SUBJECT: Forwards seismic & environ design capabilities of interim ICC/CET instrumentation at Unit 2 inside containment & responses to items in Section 7.2.2 of Suppl. 2 to Units 2 & 3 SER, per 811103 request.

Subject: Docket Nos. 50-361 and 50-362
San Onofre Nuclear Generating Station
Units 2 and 3

Seismic and Environmental Design
Capabilities of the Interim ICC/CET
Instrumentation at San Onofre Unit 2
Inside Containment.

Responses to Items Described in
Section 7.2.2 of Supplement No. 2
to the San Onofre Units 2 and 3
Safety Evaluation Report.

FIGURE B-1 EARLIEST POSSIBLE ICC INSTALLATION SCHEDULE - SONGS 2

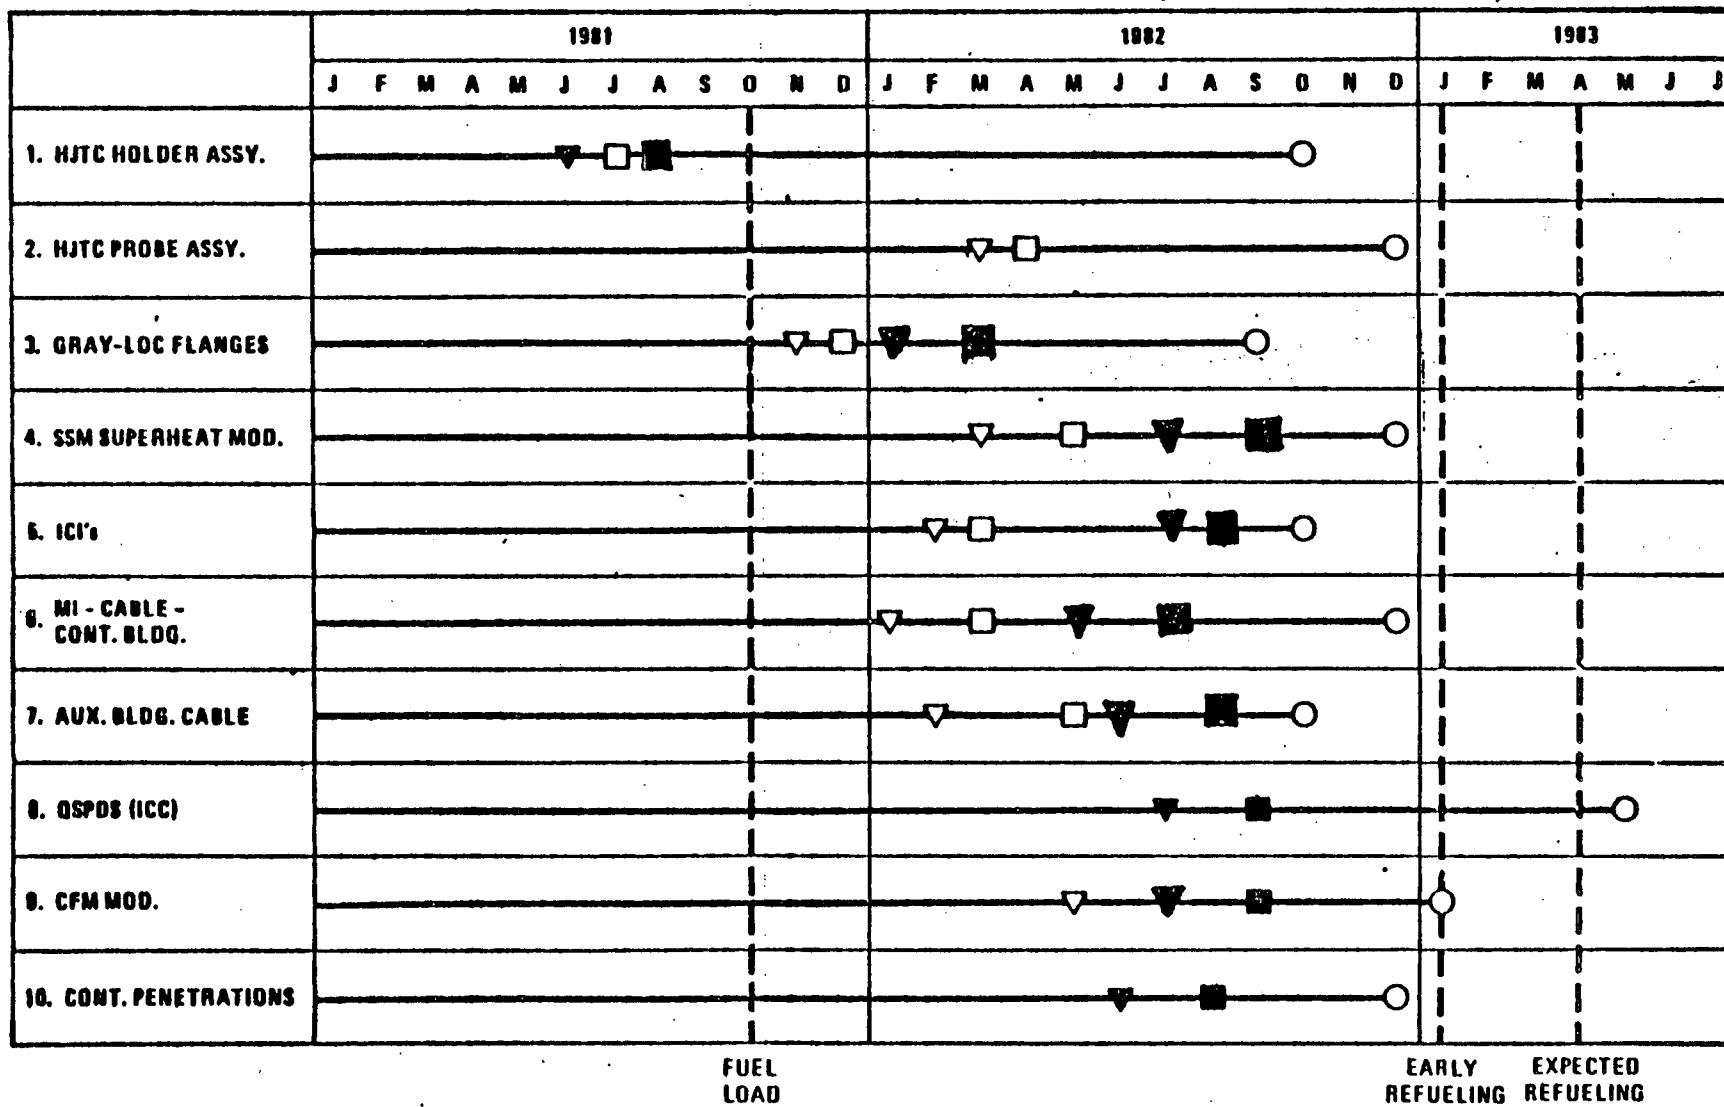
(2) The CET's were not part of the Environmental Qualification program and are not currently qualified for post-accident operation. Their existing seismic and environmental design capabilities are enclosed. The components integral to the qualification of the CETs (e.g., Mineral insulated cables, modified/qualified instrumentation flanges, modified/qualified connectors, modified/qualified Containment Penetrations) have been ordered and their delivery schedule are identified on enclosed Figure 8-1 which indicates that schedule for delivery of all the necessary components is approximately June of 1982.
